Bendix mounting

The bulletin is applicable with types of gyrocopters listed in table 1

Types of gyrocopters affected with this bulletin	
1	Zen 1
2	Xenon

Picture 1. Cracking spots on the bendix mounting.

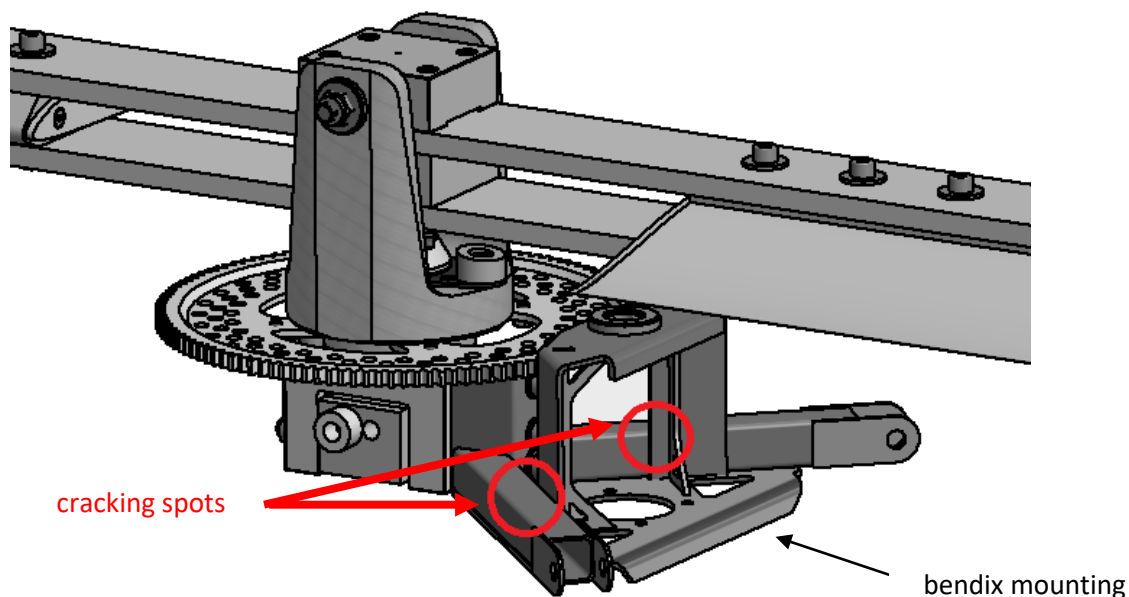
1. Before and after every flight inspect (visually or with a magnifier) the bendix mounting for cracks or other deformations. The marked spots (picture 1, picture 2) should be thoroughly checked, as they are particularly prone to cracking. If any abnormalities detected, the gyrocopter must be grounded. Contact the manufacturer to specify the way to restore airworthiness.

- Inspection of bendix mounting before and after every flight
- Main inspection of the rotor head after 500 hours
- Replacement of the rotor head after 2000 hours
